Modification to run CPU09CMI on 5MHz bus.

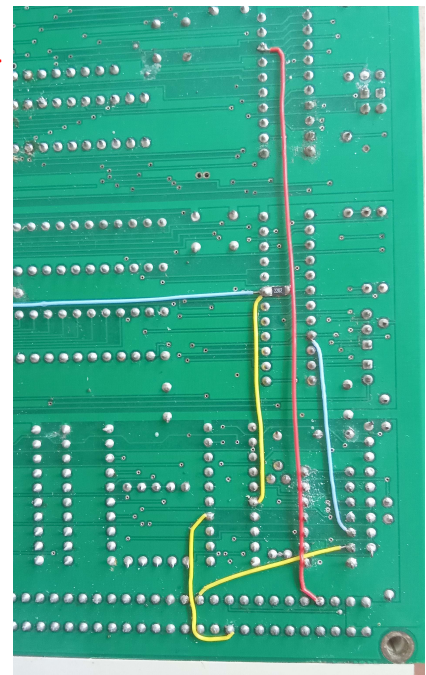
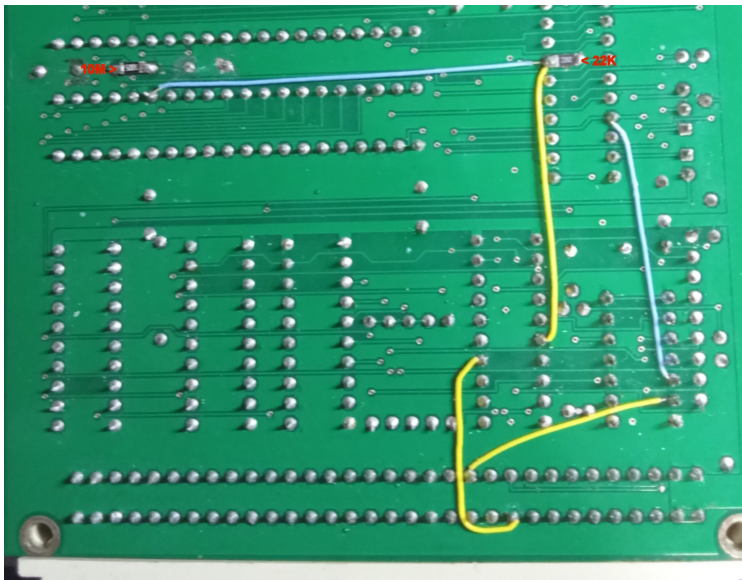
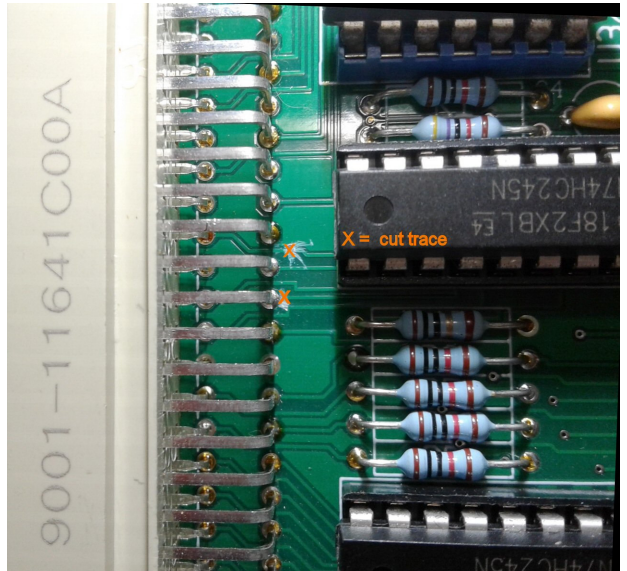
On top side:

Cut trace between U4-14 and J1 C-21 (B_VMA-)

For REV:0.9 print only cut trace from J1 A23 to R15

On solder side:

Cut trace between U13-19 and via (OVMA-)

Place 22K resistor between U13-19 and Gnd

Place wire from U6-35 to U13-19 (blue) and U4-6 (Q) (yellow)

Place wire from U4-14 to J1 A-23 (B_Q) (yellow)

Option: FLPMIN_M. >> Place wire from U14-18 to J1-C29 (red) >>

Place wire from U3-7 to J1 C-21 (B_VMA-), **Or:**
To keep CPU09CMI 68x02 compatible
or need VMA- signal with 68x02 on the bus
for CPU09GPP or CPU09RAM card.

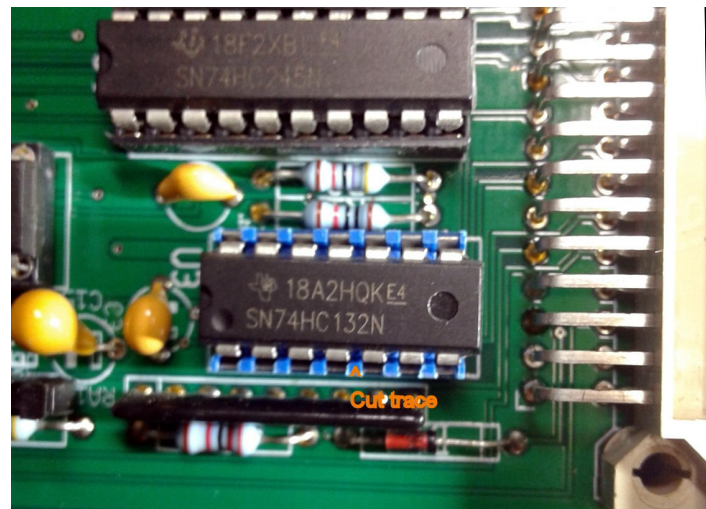
On top side:

Cut trace between U3-4 and U3-5

On solder side:

Place wire from U3-5 to U13-9 (VMA) (blue)

Place wire from U3-6 to J1 C-21 (B_VMA-) (yellow)
